Re: *Bella Flats Subdivision Approval Extension at 4111 Elmran Drive*

Please find attached three sets of the (4) four revised drawings, C1.0, C2.0, C6.0 and C6.1 addressing your comments in the incompleteness letter dated July 6th, 2010. In addition we have provided copies of the affidavit of mailing and affidavit of posting.

SUBJECT: MIS-10-15- Extension for Bella Flats Subdivision approval

SITE DIMENSION PLAN
 TENTATIVE PLAN

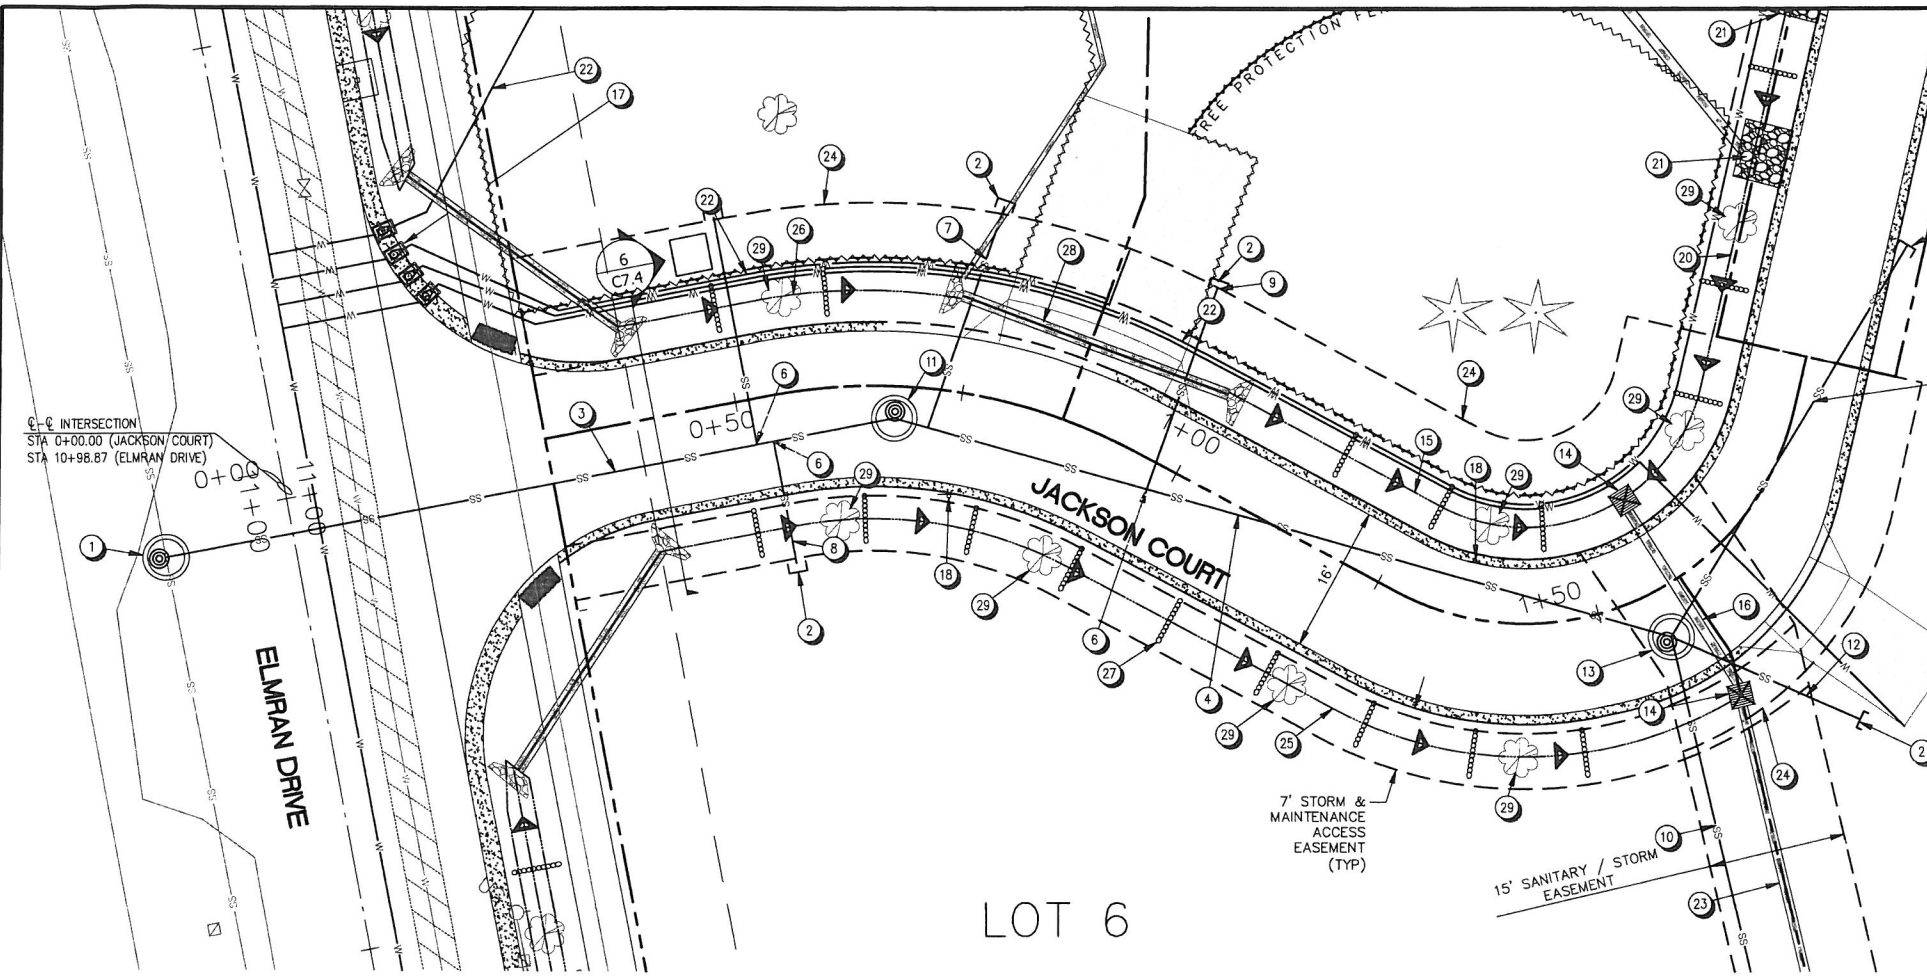
Section 85.160(D)(3)

Put "tentative plan" on Site Dimension Plan.

Section 85.160(D)(5)

Put Redside Development information on tentative plan.

Section 85.160(E)(5)

Show requested tree information on tentative plan.

Section 85.160(E)(8)

Put zoning on tentative plan.

Section 85.160(E)(9)

Show location of structures on adjoining property on tentative plan.

Section 85.170(A)(7)

Show this table on tentative plan.

PLAN AND PROFILE
ELMRAN DRIVE
STA 9+00.00 TO STA 13+66.26

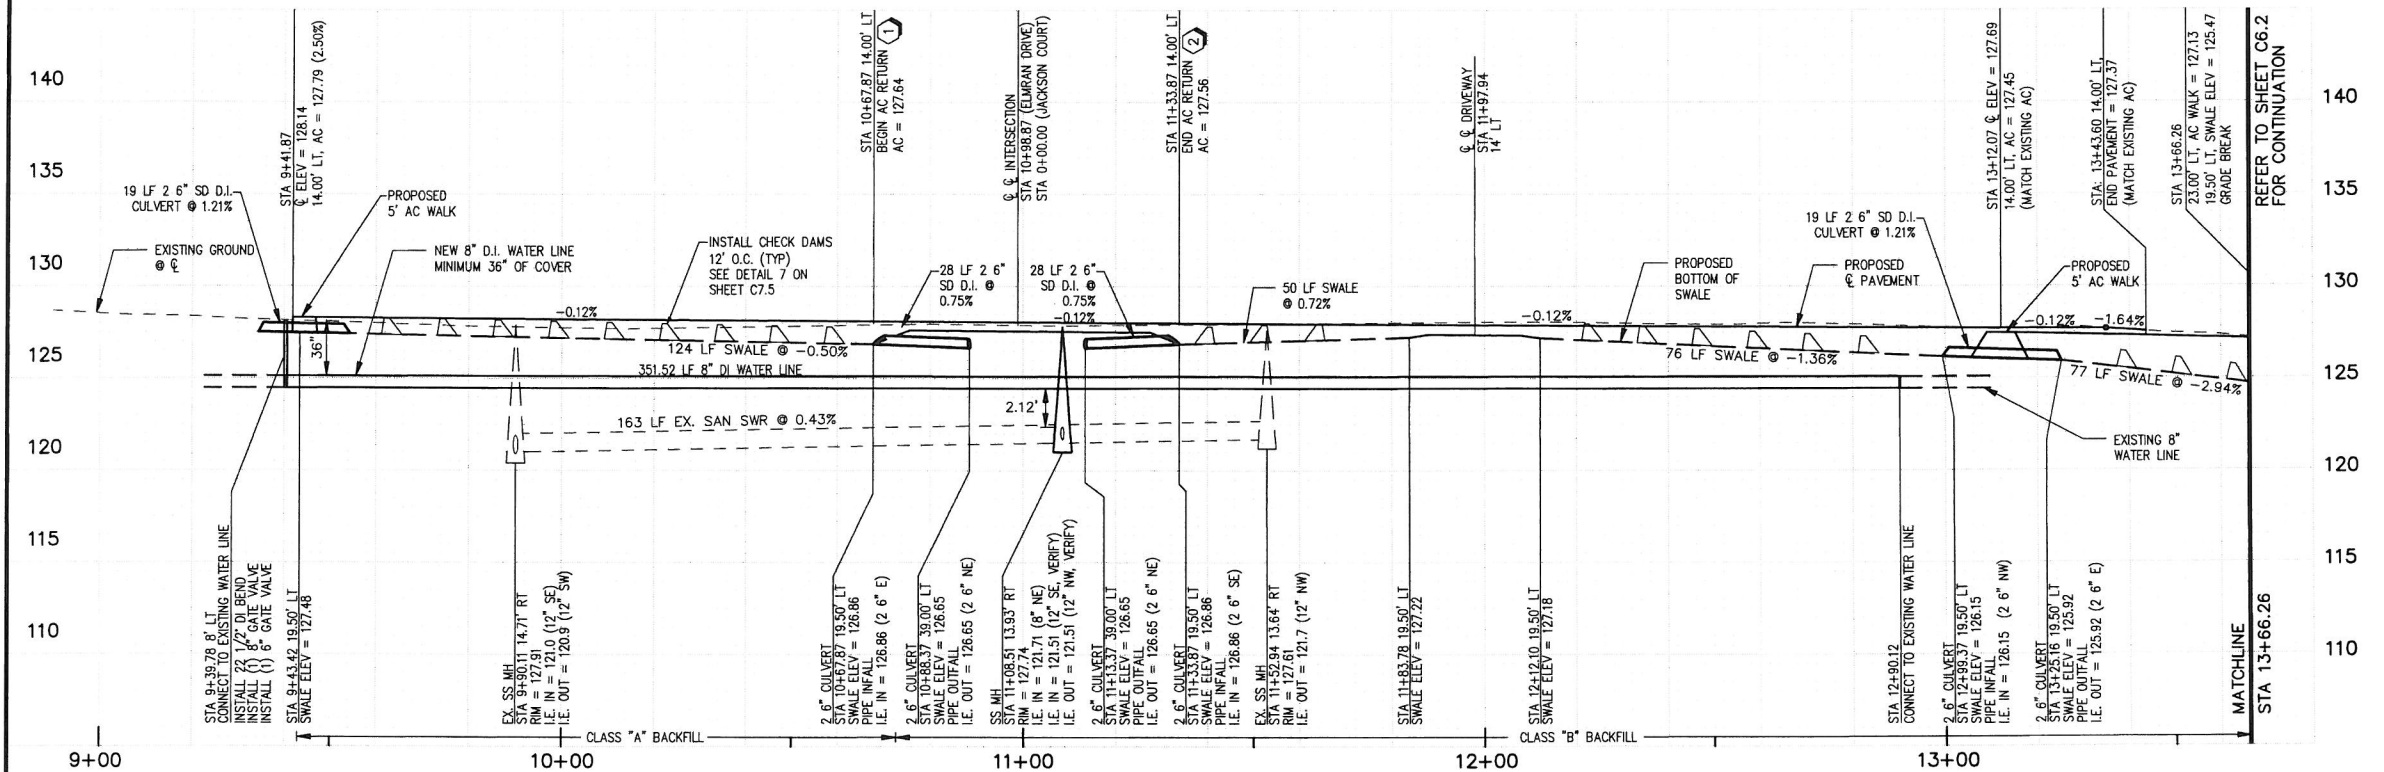
Show proposed crosswalk on site plan.

- 17 STRIPING CROSS WALK SEE DETAIL
- 18 31 LF SWALE SEE DETAIL
- 19 19 LF 2 6" SD D.I. PIPE
- 20 28 LF 2 6" SD D.I. PIPE
- 21 28 LF 2 6" SD D.I. PIPE
- 22 BIKE / PEDESTRIAN RAMPS MUST BE ADA COMPLIANT W/ A MAXIMUM SLOPE OF 1V:12H. SEE DETAILS
